DESIGN REVIEW RECOMMENDATION  
MAY 6, 2024 MEETING

SDCI #3040275-LU  
6102 14th Ave NW  
Seattle, WA 98107

Applicant:  
Cone Architecture  
1319 N 49th Street  
Seattle, WA 98103  
Contact: Emily Terzic

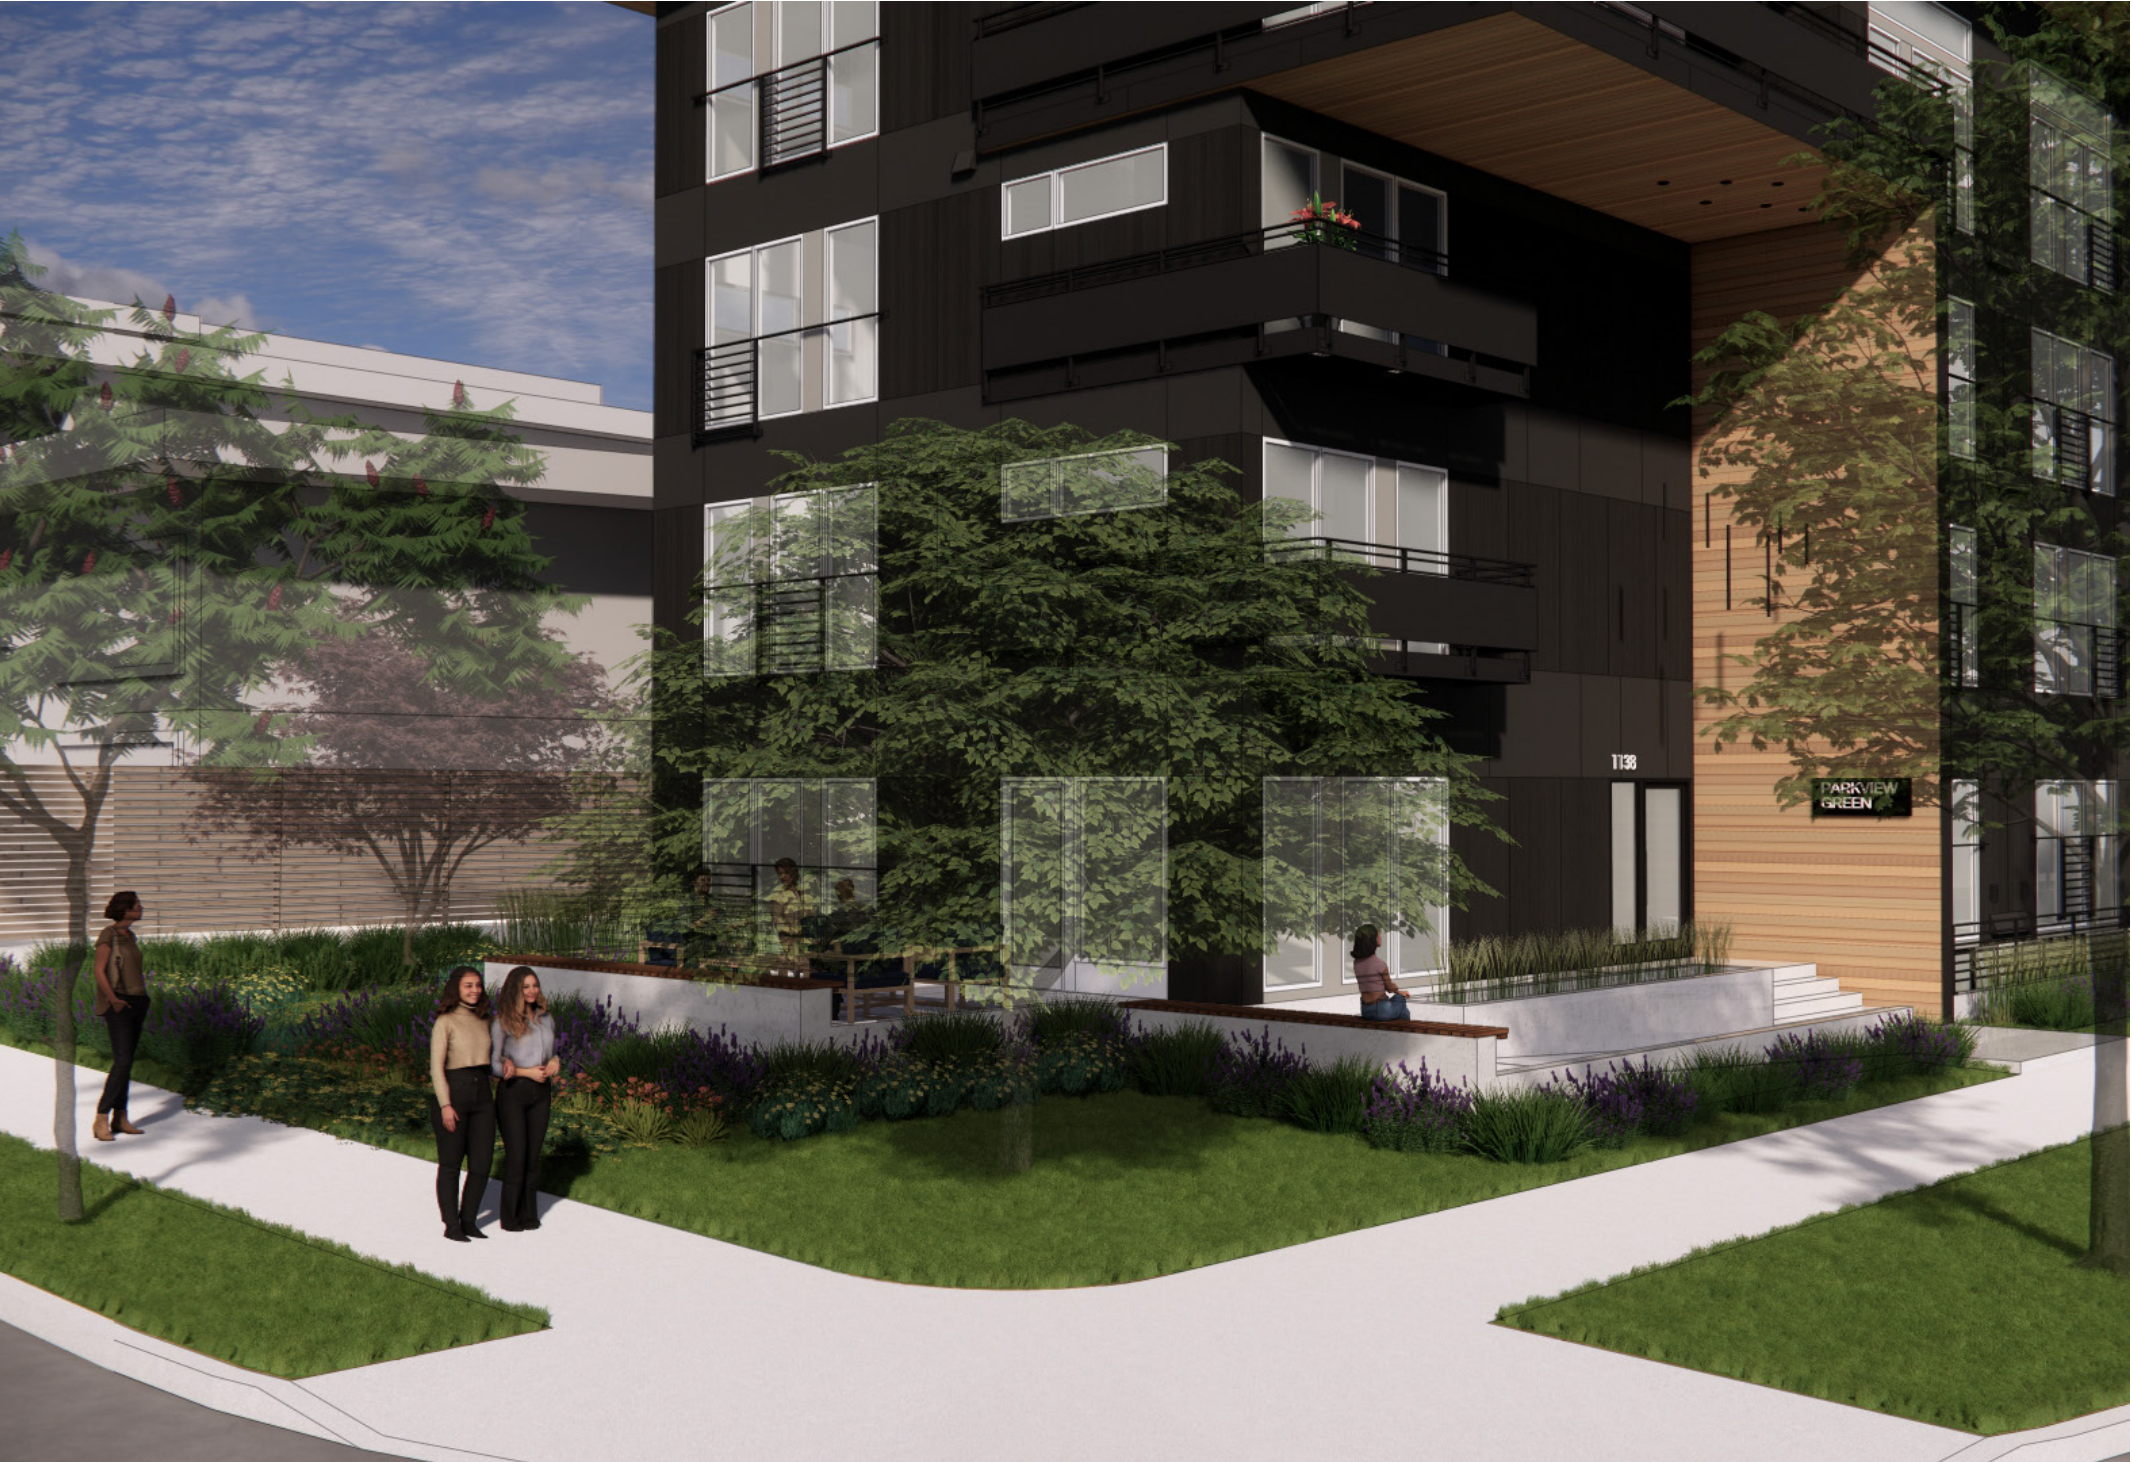
*The Board supported the intent for the placement of amenity spaces along street frontages in Option 3 and emphasized the need to maintain physical and/or visual interaction between the amenity spaces and the street frontages by minimizing the heights of fences and other physical barriers along street frontages.*

The proposed design maintains a visual connection from the hardscaped amenity spaces at the southwest and southeast corners of the site to the adjacent sidewalks. Rich plantings, instead of fencing, is located along the western property line, to create a soft buffer for the private patio space from sidewalks, while still allowing some transparency and views to and from.

PEDESTRIAN VIEW ALONG NW 61ST ST

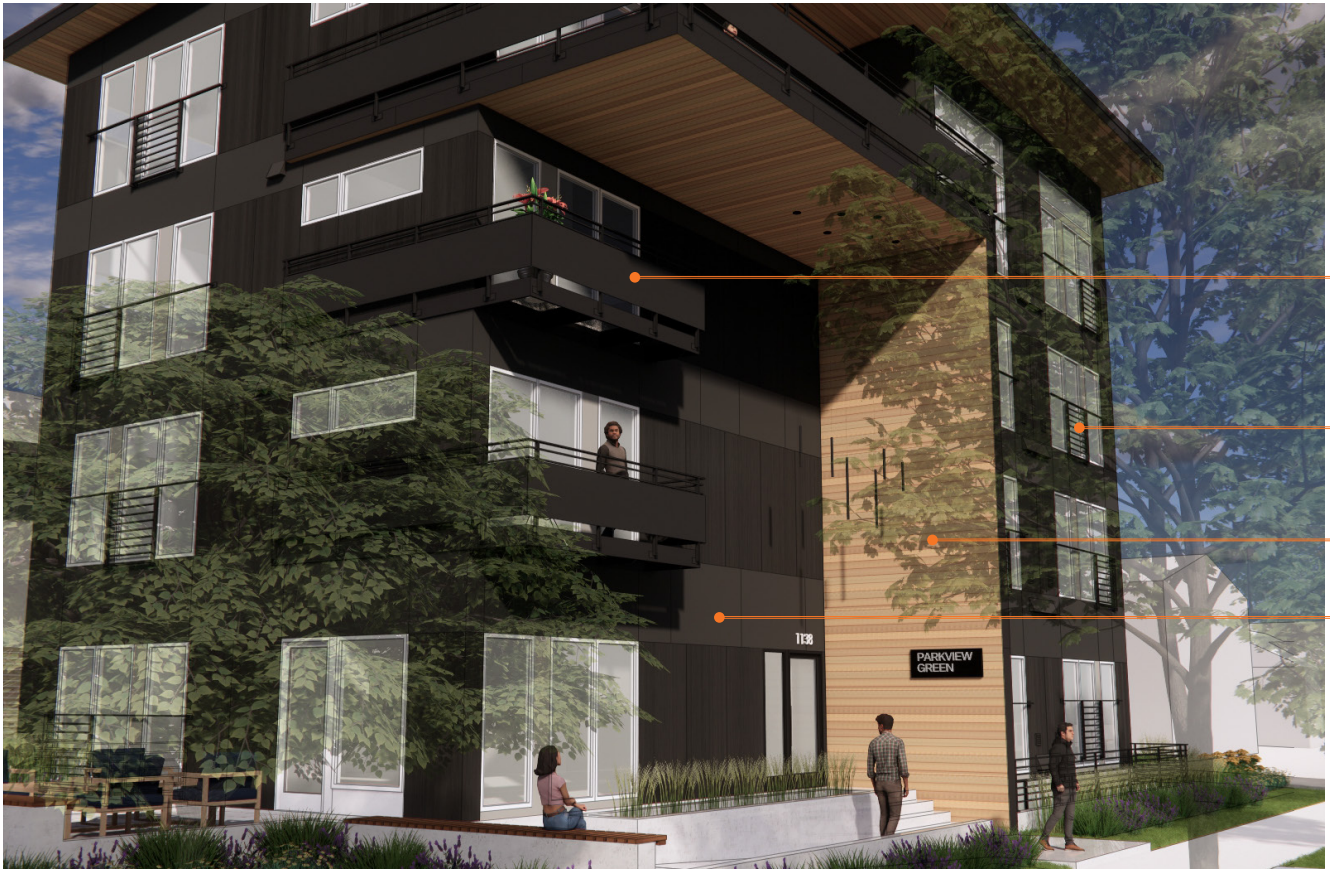
The Board emphasized the need for secondary architectural features to aid in the reduction of the building scale (CS2-D. Height, Bulk, and Scale, CS3-A-4. Evolving Neighborhoods, DC2-B-1. Façade Composition, DC2-C. Secondary Architectural Features).

A simple material palette is proposed, composed of a variety of smooth and textured fiber cement panels with warm wood accents, relating to the neighboring material context. The various panel types interact through playful material breaks and infill moments.

Juliet balconies at the south and west facades add visual interest and depth to the overall composition of the building. To further reduce the building scale, the fourth level deck has been combined with a fin wall to engage the street, providing overhead weather protection for the identifiable residential entry. Two additional decks have been added below the fourth floor deck, following contextual patterns, and reducing the height of the overall form.

Cedar soffits at the fourth level deck and roof are proposed to provide a sense of warmth from the pedestrian view, while also balancing the monochromatic nature of the smooth and textured panel.
